Re: 10026 Central Ave SE
Project Address
Traffic Circulation Layout
Engineer's/Architect's Stamp 01-14-2020 (L20D073)

Based upon the information provided in your submittal received 01-14-2020, the above referenced plan cannot be approved for Building Permit until the following comments are addressed:

Sheet: Fire-2

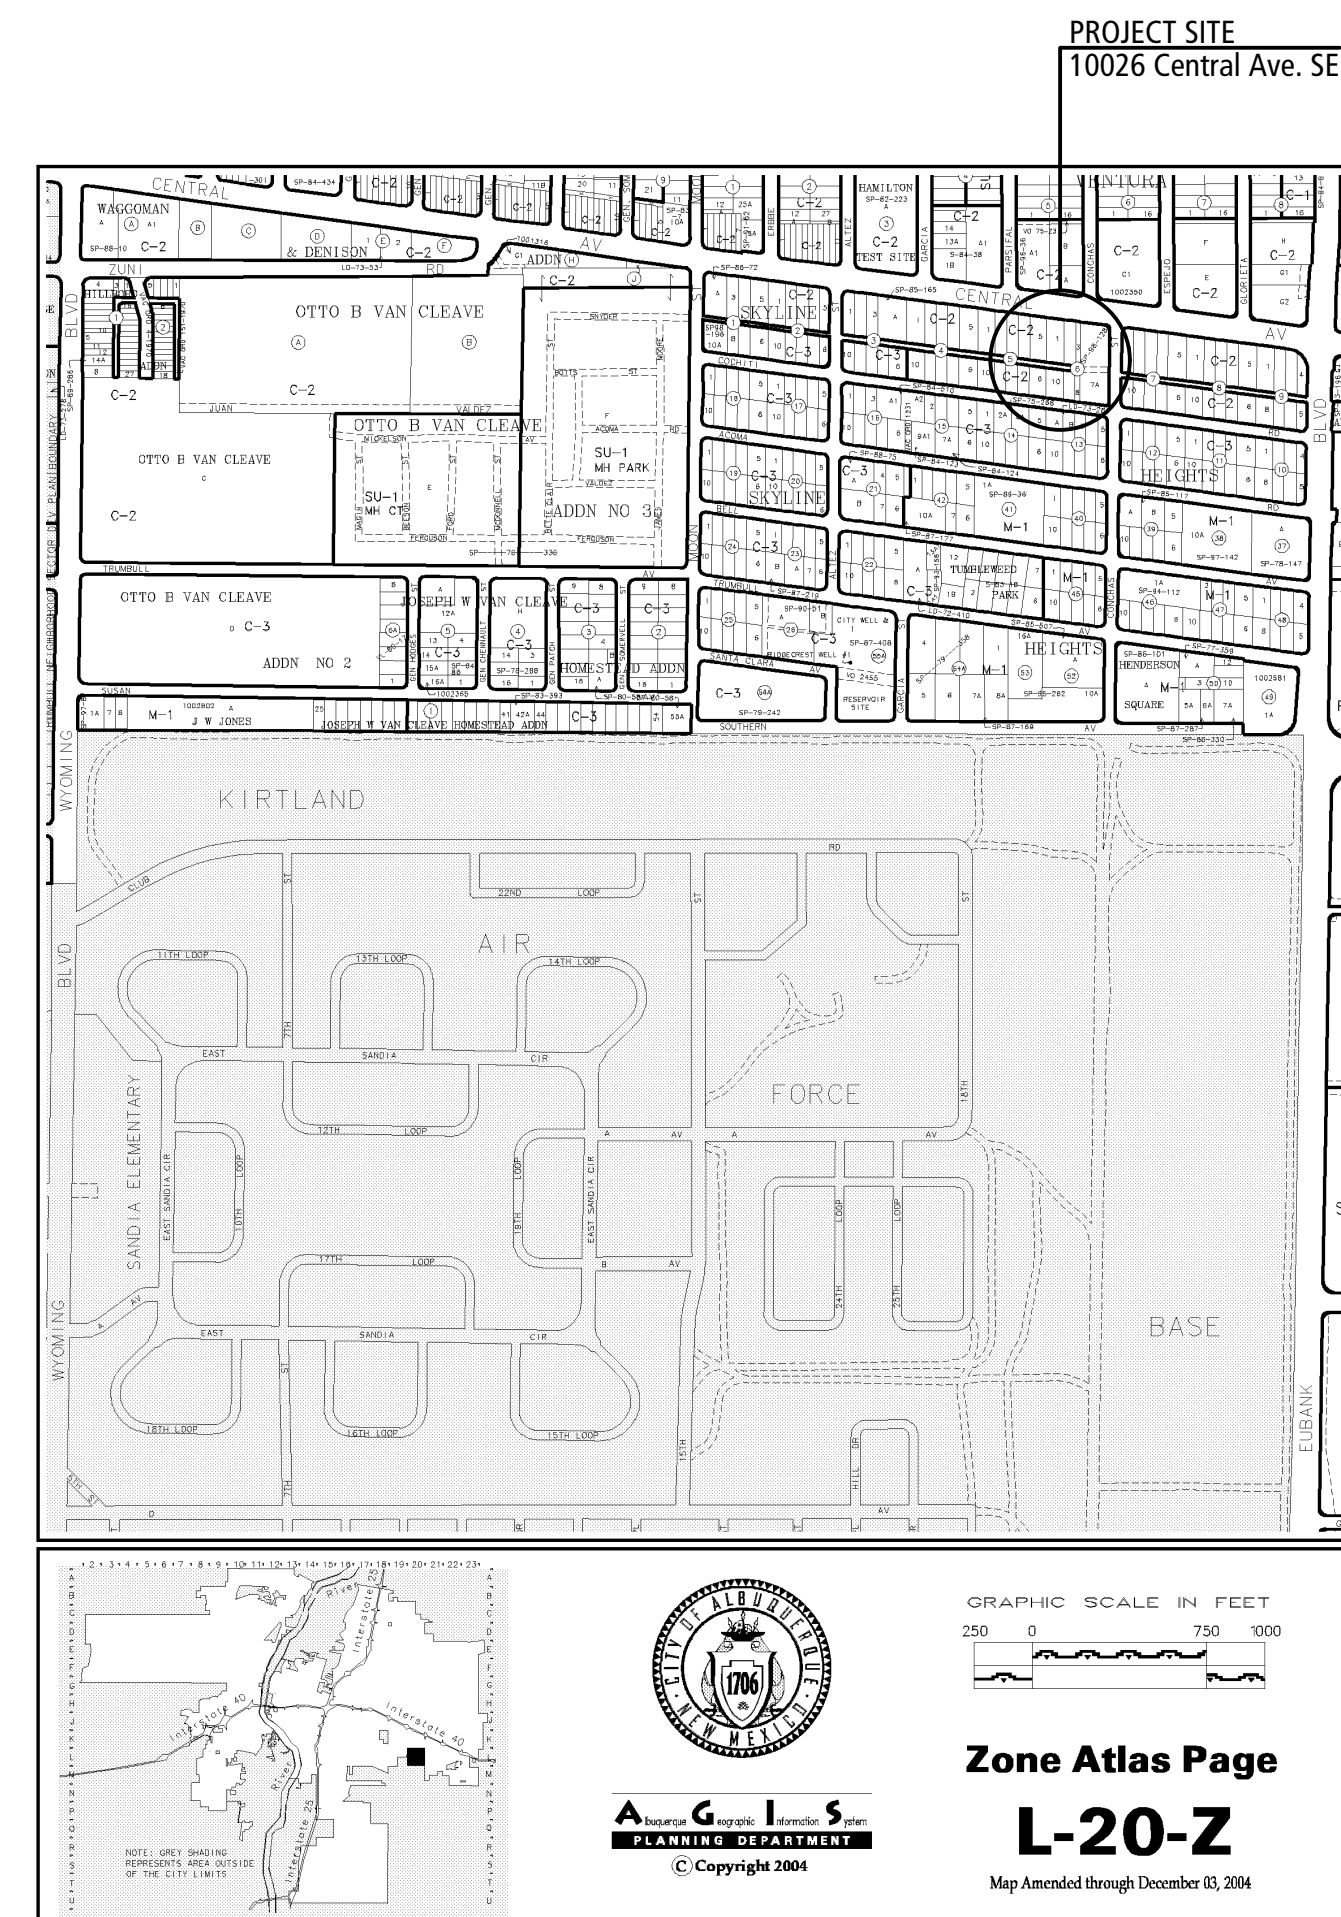
1. On the vicinity map, please identify the property.
2. Correct the address both on the DTIS form and on the site plan: 10020 Central Ave is not the correct address.
3. The scale must be shown on the plan. Per the Development Process Manual, Chapter 27, Section 2, Part B.1, on the following scales may be used:

1" = 20'	1" = 40'
1" = 50'	1" = 100' (for overall layouts only)
4. The ADA accessible parking sign must have the required language per 66-7-352.4C NMSA 1978 **"Violators Are Subject to a Fine and/or Towing."** Please call out detail and location of signs.

5. ADA curb ramps must be updated to current standards and have truncated domes installed.
6. Please call out the pedestrian pathway connection to the public sidewalk.

7. Refuse vehicle maneuvering shall be contained on-site. The refuse vehicle shall not back into the public right of way.; provide a copy of refuse approval.

8. It is not apparent what type of pavement surface is being proposed. A hard driving surface will be required as part of this proposed project for parking area and drive aisles.

9. All one-way drives shall have "One Way" and "Do Not Enter" signage and pavement markings. Please show detail and location of posted signs and striping.

10. Show the clear sight triangle and add the following note to the plan:
"Landscaping and signage will not interfere with clear sight requirements."

Therefore, signs, walls, trees, and shrubbery between 3 and 8 feet tall (as measured from the gutter pan) will not be acceptable in the clear sight triangle.

11. Shared Site access: driveways that straddle property lines, or are entirely on one property but are to be used by another property, shall have an access easement. Please include a copy of your shared access agreement with the adjacent property owner.
12. Add a note stating "All broken or cracked sidewalk must be replaced with sidewalk and curb & gutter." A build note must be provided referring to the appropriate City Standard drawing.
